**STAFF ANALYSIS
OF THE
WHITE ROSE DEVELOPMENT PLAN
AMENDMENT APPLICATION

WHITE ROSE EXTENSION PROJECT**

The purpose of this document is to provide the Board with an assessment of Husky Oil Operations Limited (Proponent) White Rose Development Plan Amendment (DPA) for the White Rose Extension Project. This analysis considered safety, operations, environment and resource management aspects of the Development Plan amendment application.

Figure B.8: Hydrocarbon pore volume (gas) of West Pool base-case assessment with NTG applied.

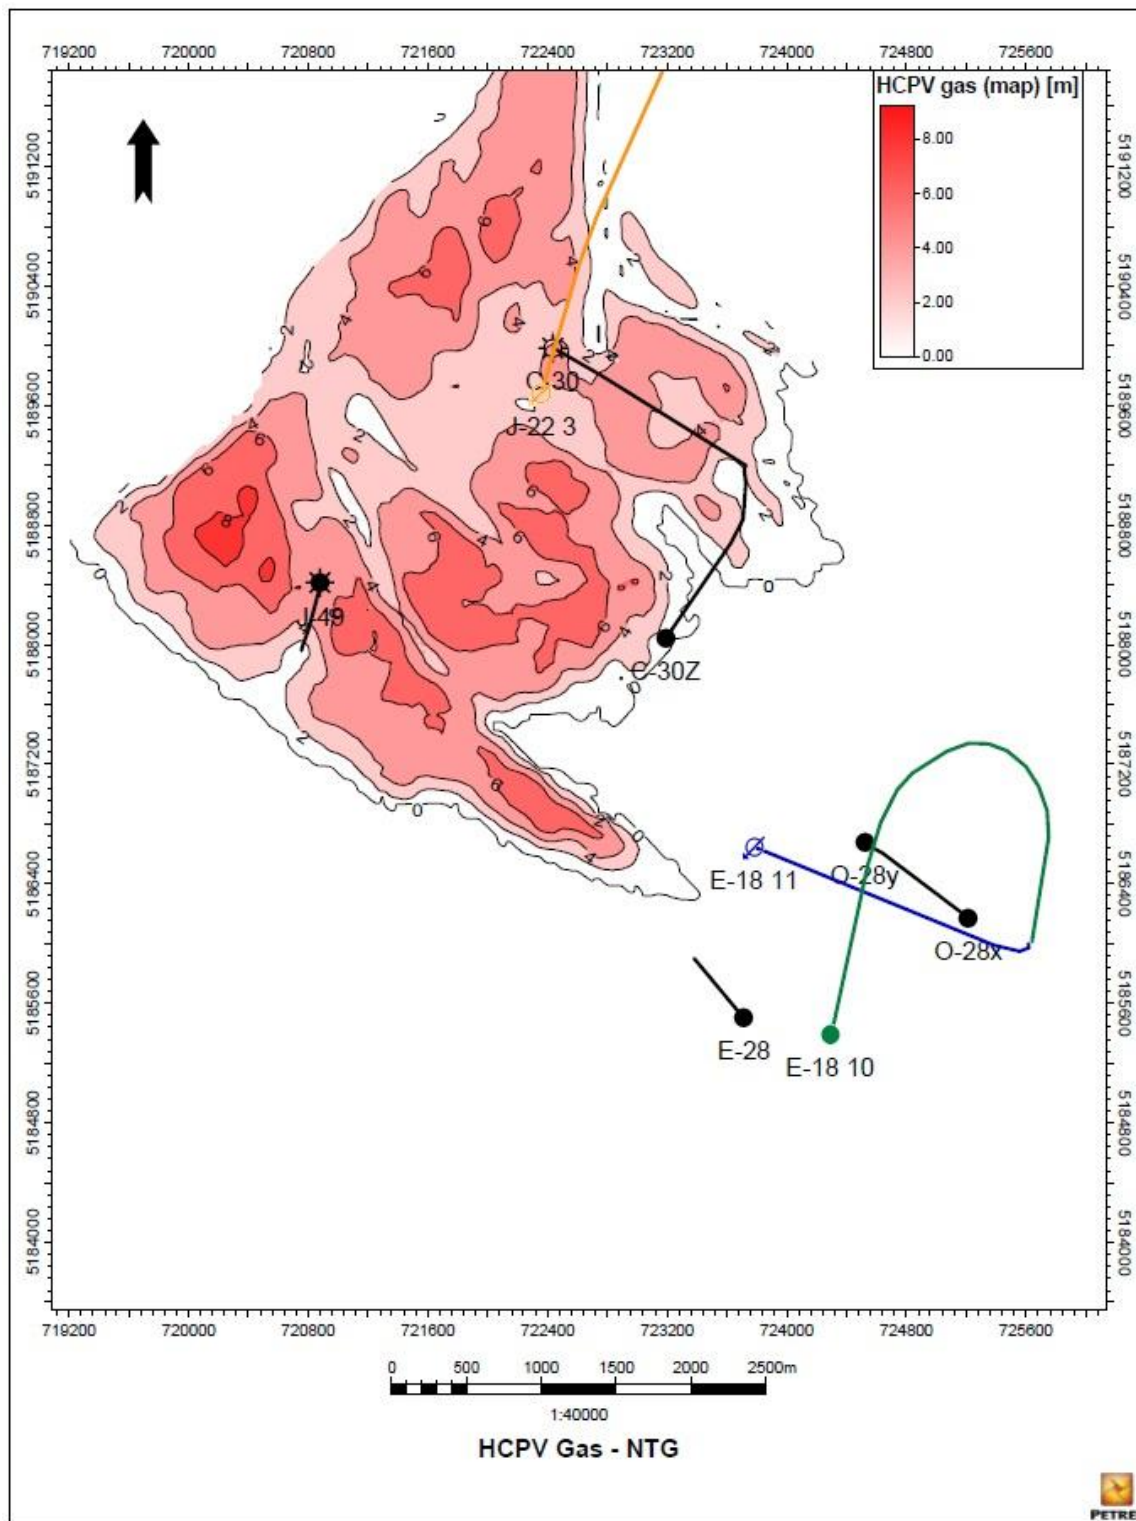
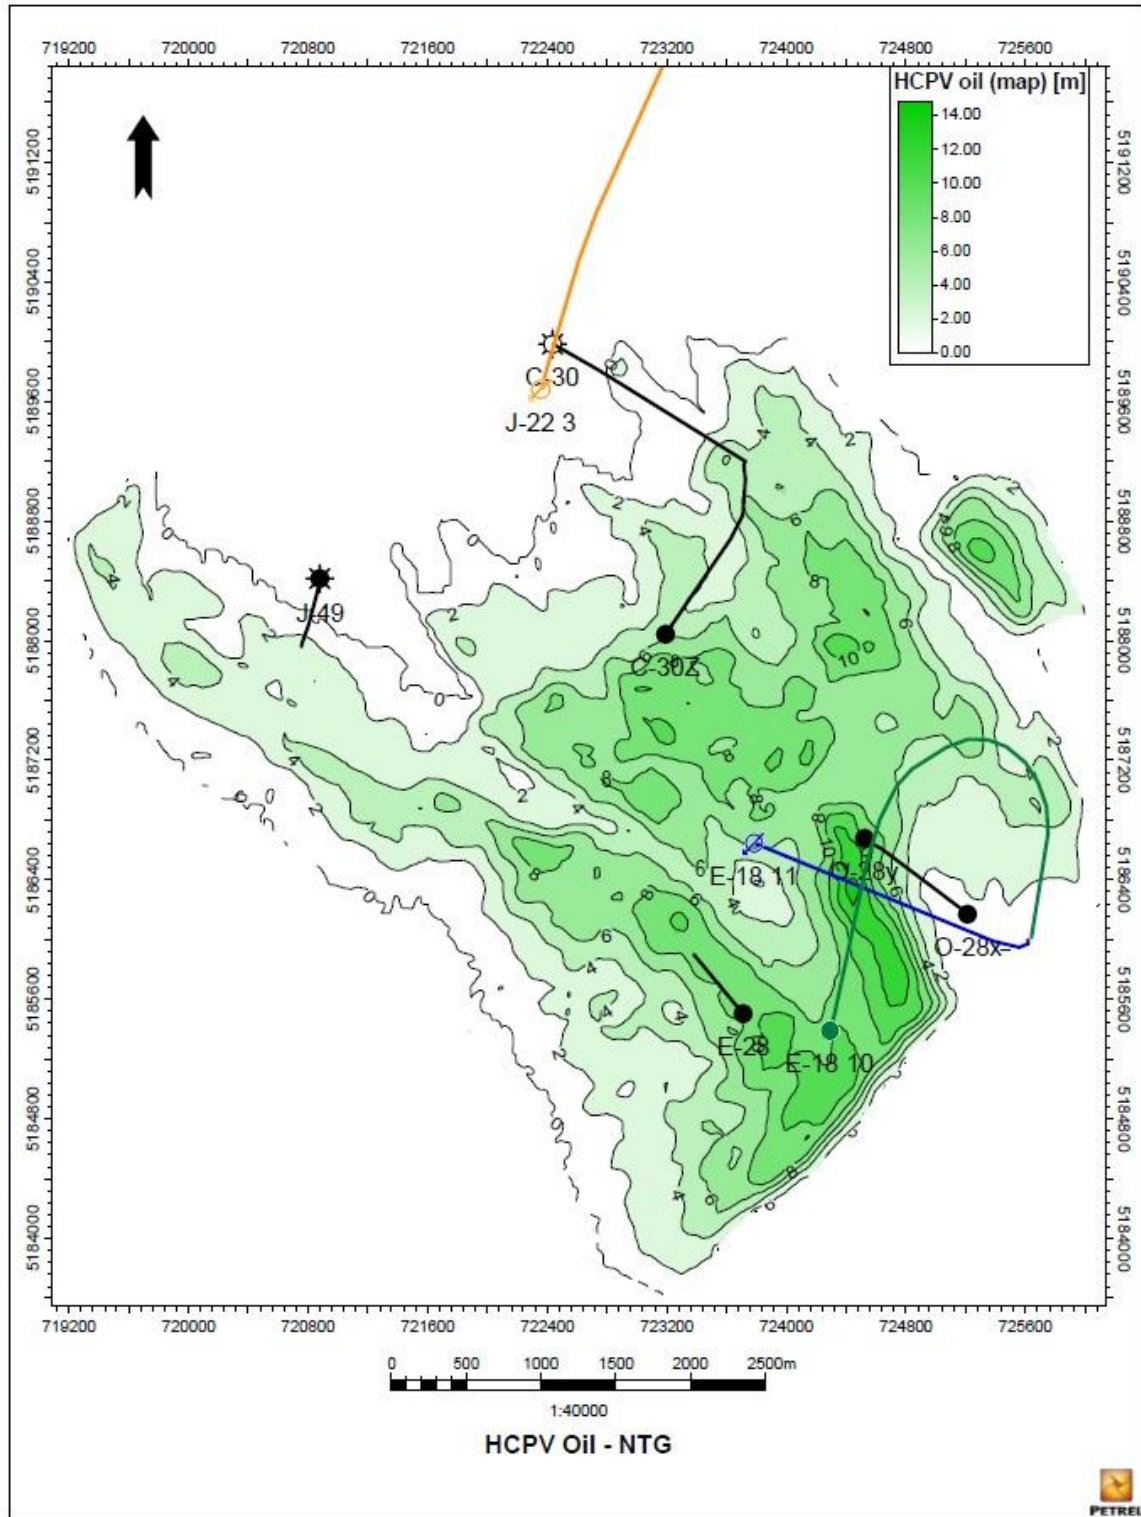
Overall, there is a discrepancy between the Proponent's and the staff's volumetric assessment. Differences between the Proponent's and staff's STOOIP and OGIP estimates are attributed to variations in geological and reservoir modelling approaches, petrophysical analyses and parameters varied in the uncertainty analysis. However, Board staff also ran a base-case volumetric assessment scenario applying the NTG cutoffs in Table B.2. The NTG filter applied to the fluid contacts region (Figure B.4) is shown in Figure B.7. The results in Table B.3 are comparable to the P50 results provided by the Proponent in the Application (Table B.1). Hydrocarbon pore volume gas and oil maps with the NTG considered for the region are shown in Figure B.8 and Figure B.9.

Figure D.2: C-NLOPB West Pool equilibrium regions.

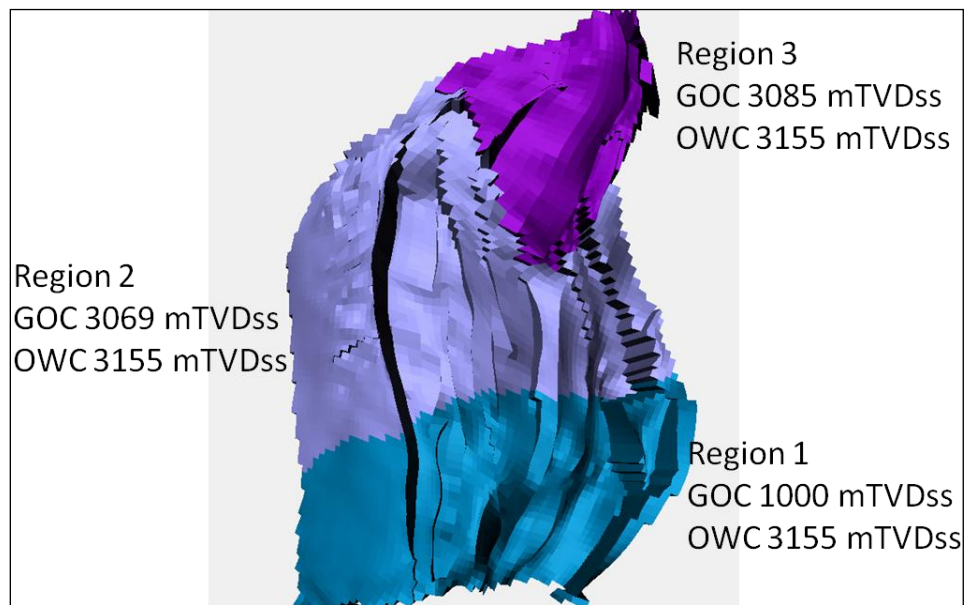
interpretation of 3155 m TVDss was used for each equilibrium region in the model. This differed from the Proponent's regions which used an OWC of 3170 m TVDss. An illustration of the equilibrium regions used in staff's model can be seen in Figure D.2.

Figure D.5: C-NLOPB vs. Proponent base-case gas production for West Pool.

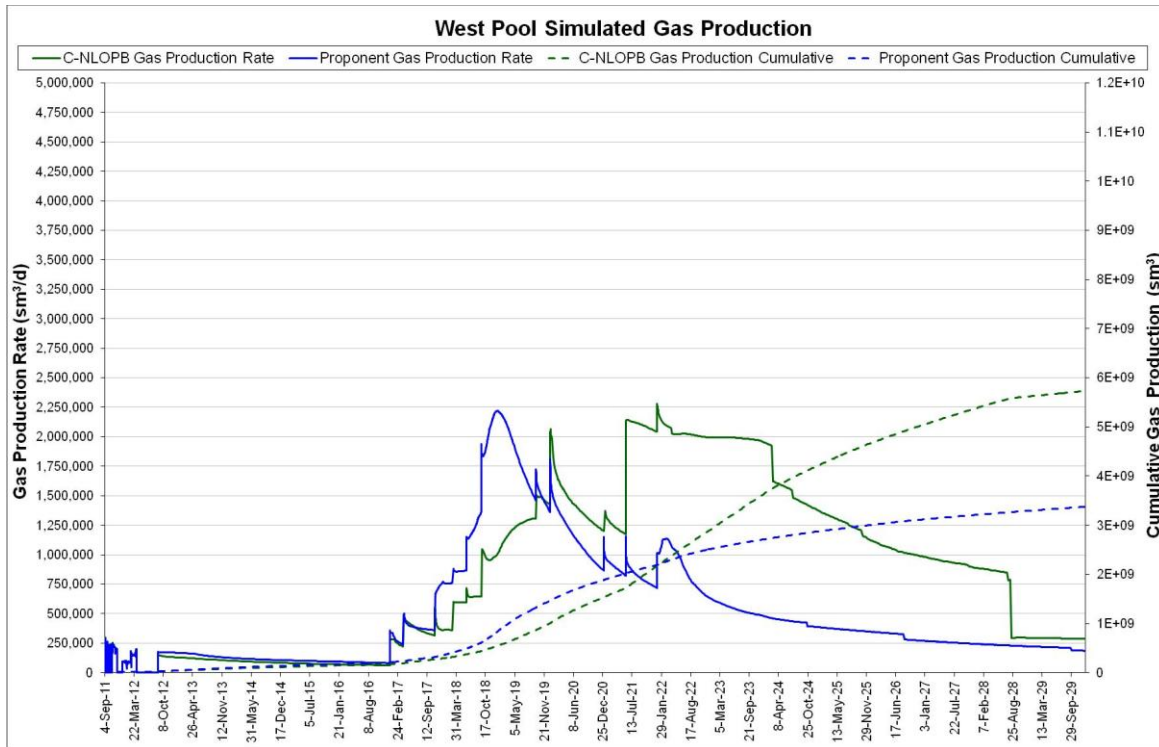
As shown in Figure D.5, staff's model and the Proponent's model reach similar peak gas production rates, with the Proponent's peak arriving earlier, while staff's arrives later but is more prolonged. As a result of the prolonged period, staff's cumulative gas production is higher than the Proponent's. These differences in gas production are primarily due to the different structural interpretation used for staff's model and the equilibrium regions that were created as a result. Due to the equilibrium region set up, the West Pool gas cap extends farther laterally in staff's model than in the Proponent's. This causes gas breakthrough from the gas cap in the northernmost producers in staff's model, so these wells have higher and more sustained gas production rates than the same wells in the Proponent's model. Staff could have made adjustments to the equilibrium regions to address these issues but time constraints did not allow this. Slight adjustments were made to the well trajectories and completions, but in the interest of honouring the proposed depletion scheme, no major adjustments to well location were made for these producers.

Figure D.9: C-NLOPB vs. Proponent base-case water production for North Pool.

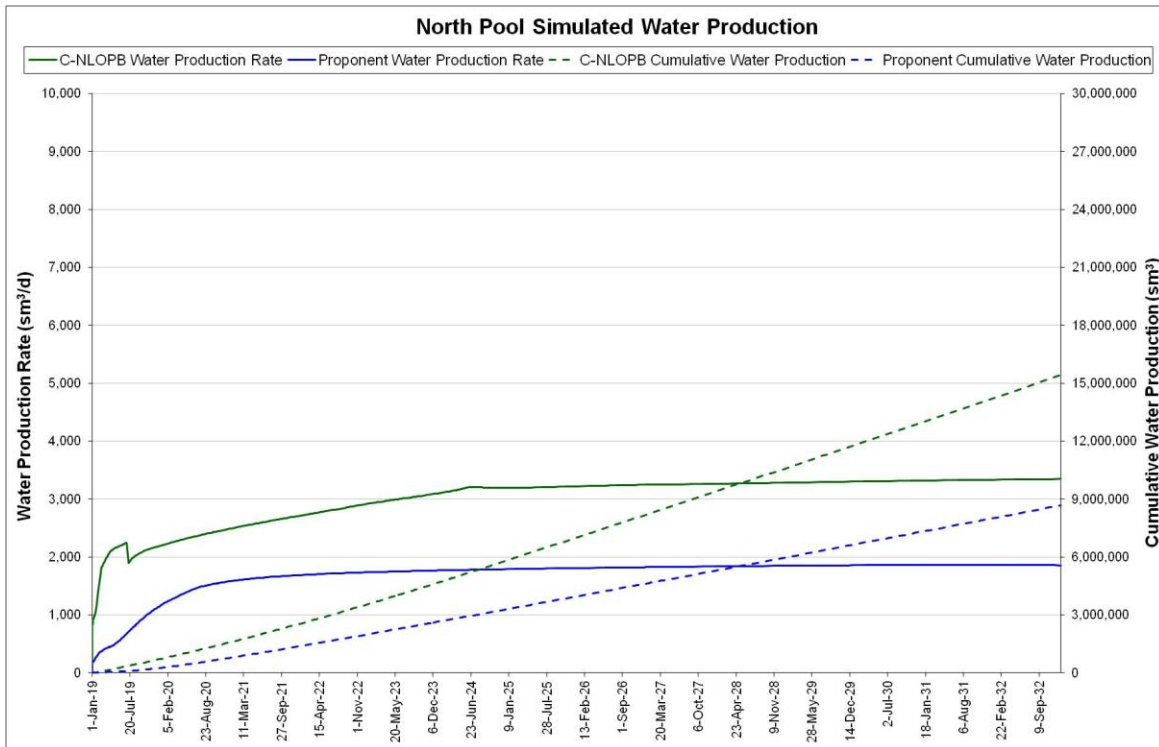
As illustrated in Figure D.9, the water production rate from staff's model is higher than the Proponent's. This is mainly due to the water saturation distribution from staff's geological model being higher than the Proponent's water saturation. Also, as mentioned, the main producer in staff's model was placed closer to the OWC than the producer in the Proponent's model. Due to time constraints, staff was unable to investigate the higher water saturation distribution further or to make adjustments to the model to attempt to decrease the water production.

Figure D.11: C-NLOPB vs. Proponent base-case reservoir pressure for North Pool.

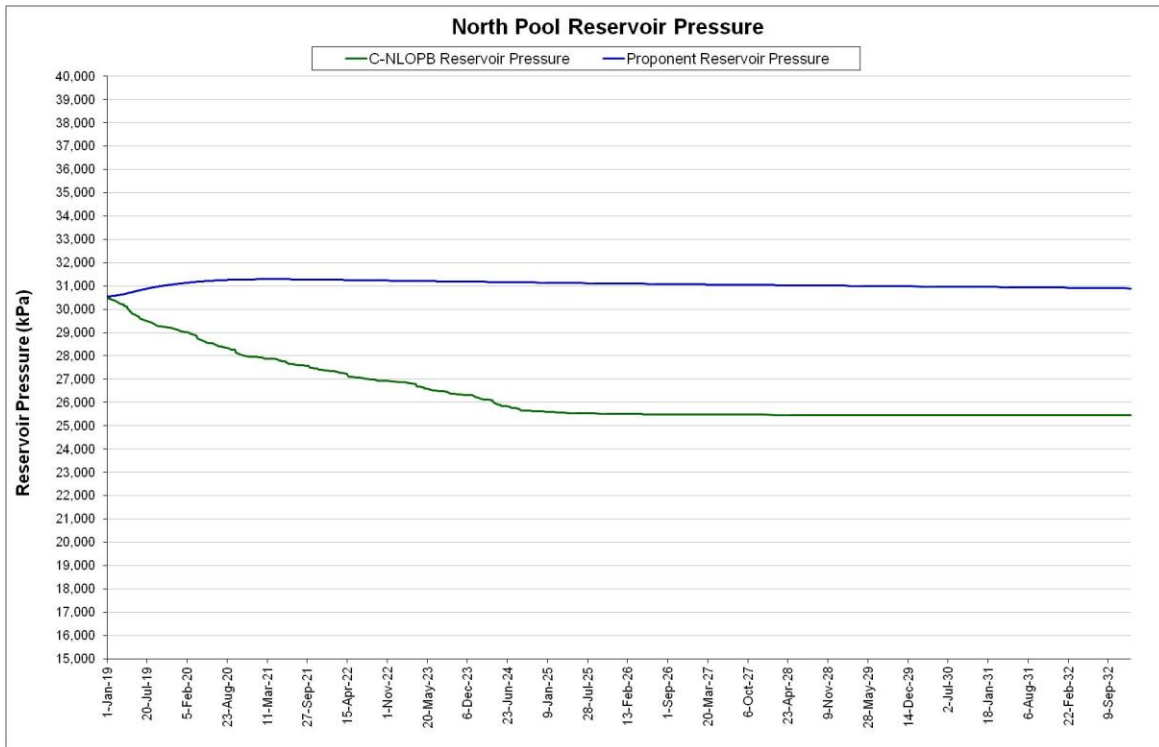
As shown in Figure D.11, the reservoir pressure in staff’s model begins to decrease as soon as production begins, before levelling off in mid year 2024, while the reservoir pressure in the Proponent’s model remains stable throughout the forecasted period. The drop in pressure in staff’s model is most likely due to the water injector in staff’s model not being optimized for the structure and properties in the model. This results in the water injector being unable to provide adequate pressure support for the producers in staff’s model. As discussed, staff would have liked to attempt to optimize the location of the water injector in the model and further investigate the cause of the drop in reservoir pressure, but were unable to due to time constraints. The drop in reservoir pressure in staff’s model may have also contributed to the higher gas production compared to the Proponent’s.
